PROJECT NO. AV15000073
AVIATION DEPARTMENT
PHOENIX SKY HARBOR INTERNATIONAL AIRPORT
RENTAL CAR CENTER LED LIGHT RETROFIT
DESIGN-BID-BUILD

ADDENDUM NO. 3

ISSUE DATE: November 17, 2023

BUILDING SIXT -- LIGHTING PLAN
 SCALE: 3/16" = 1'-0"

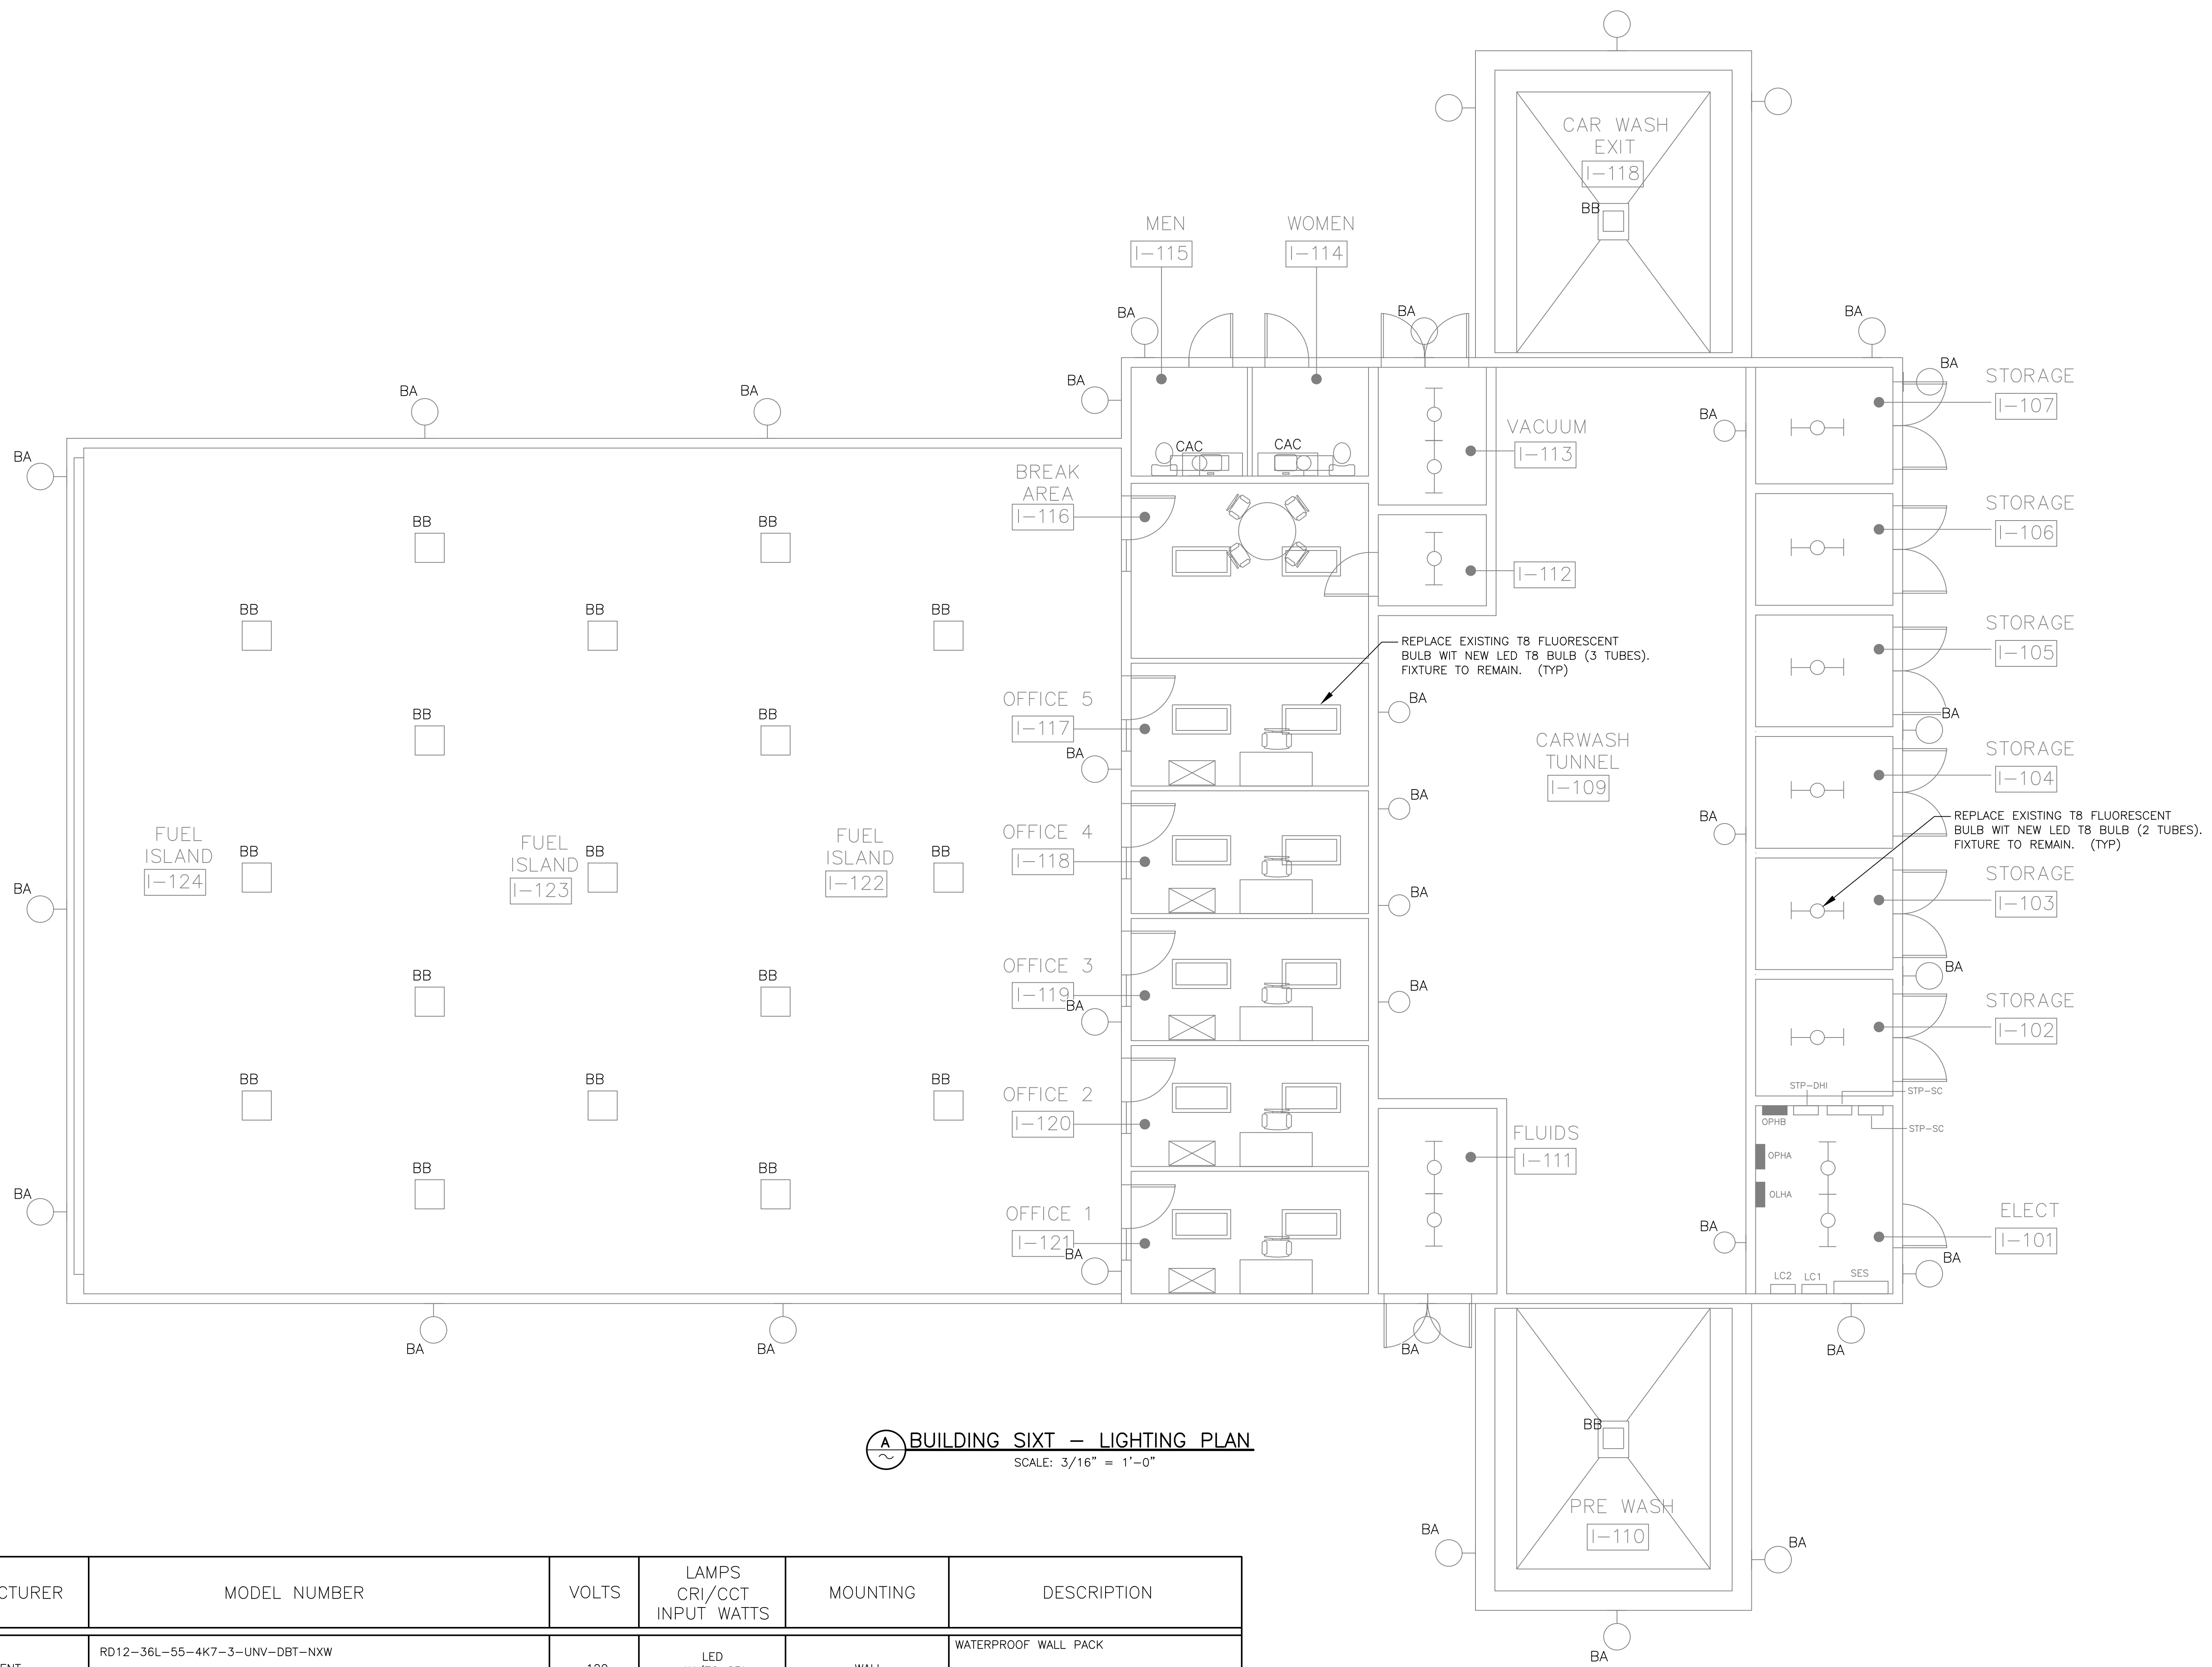
1. Add the following new plan sheets (attached):
 - a) E10.3: BUILDING SIXT LIGHTING PLAN
2. Delete the following plan sheets and replace sheets with the attached (see clouded areas for specific plan changes)
 - a) E00.1: ELECTRICAL DRAWING INDEX (Addition to Drawing Index of Sheet E10.3 Building Sixt Lighting Plan)
 - b) E3.2 LIGHTING PLAN LEVEL 3 RENTAL CAR AREA 2 (Addition of two SA fixtures)
 - c) Removed areas of the Rental Car Core Buildings as the City of Phoenix has already completed the LED upgrades (shown in the clouded areas). E4.1 LIGHTING PLAN LEVEL 4 CSB AREA 3B
E4.3 LIGHTING PLAN LEVEL 4 CSB AREA 5B
E4.4 LIGHTING PLAN LEVEL 4 CSB AREA 6A
E4.6 LIGHTING PLAN LEVEL 4 CSB AREA 7B
E4.7 LIGHTING PLAN LEVEL 4 CSB AREA 8A

ENLARGED SITE LIGHTING PLAN
 SCALE: 1/16" = 1'-0"

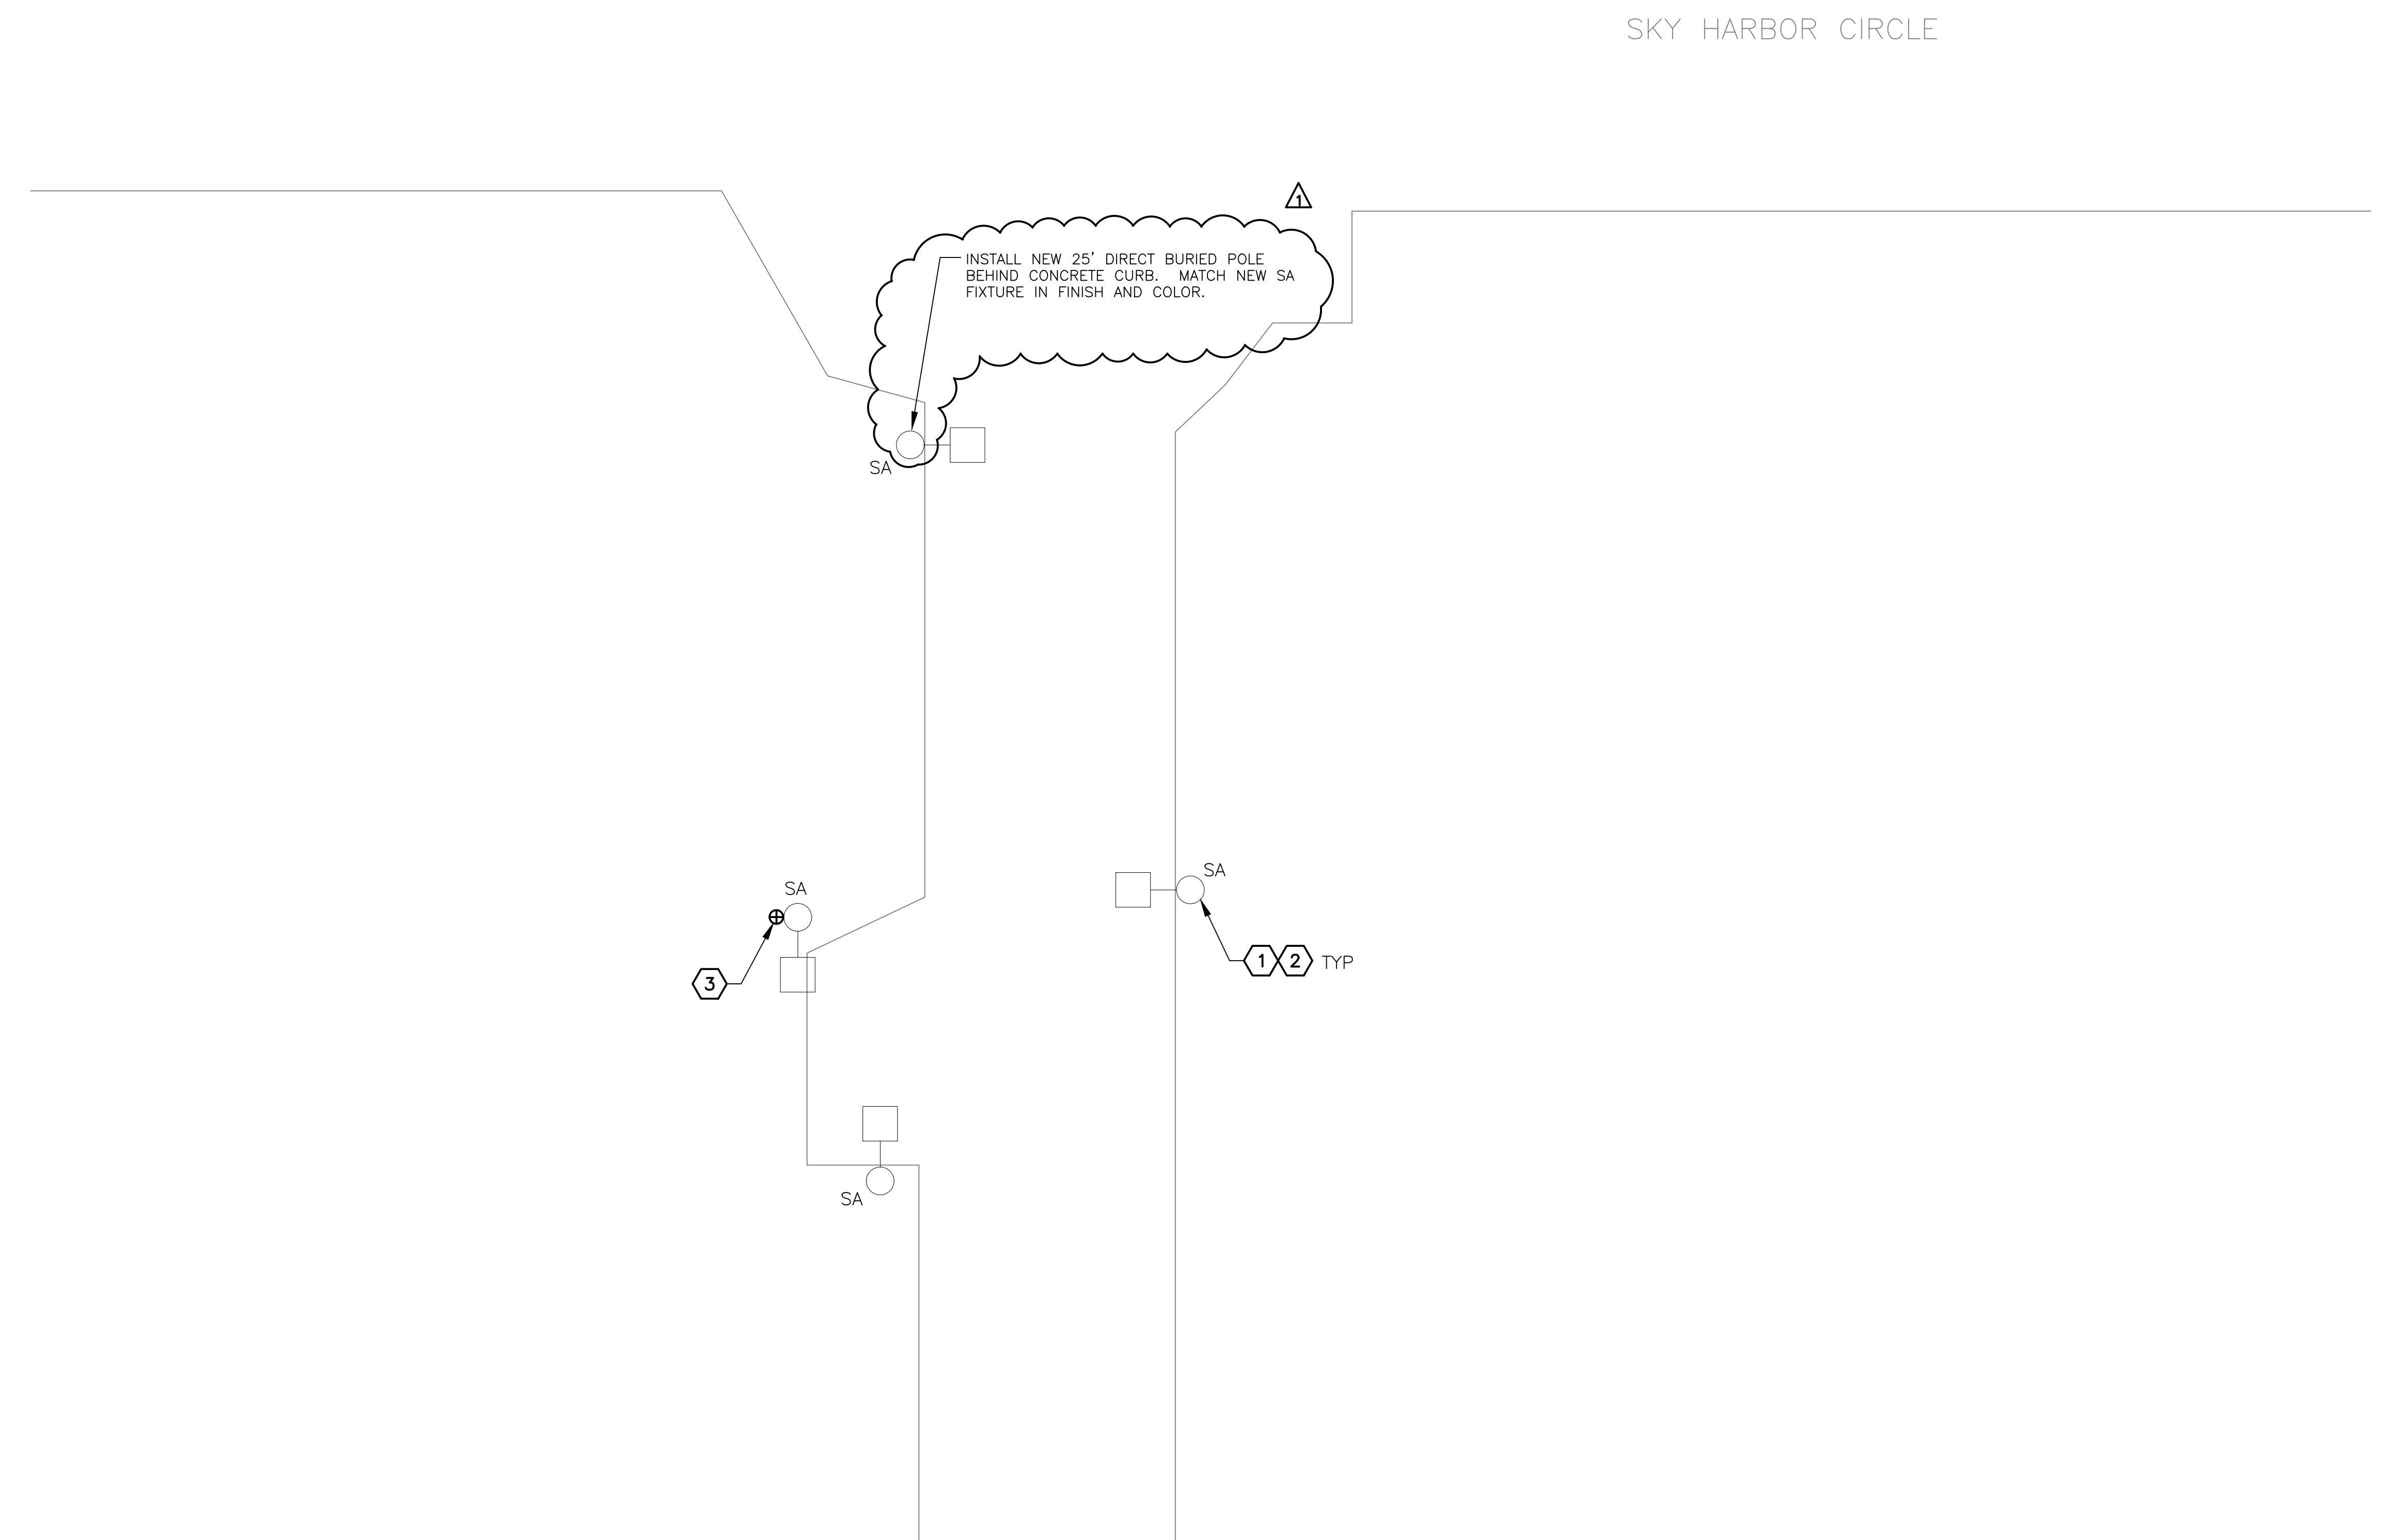
- d) E11.3 ENLARGED SITE LIGHTING PLAN (Addition of 1 25' direct buried light pole that was damaged at the entrance to drive off Sky Harbor Circle).
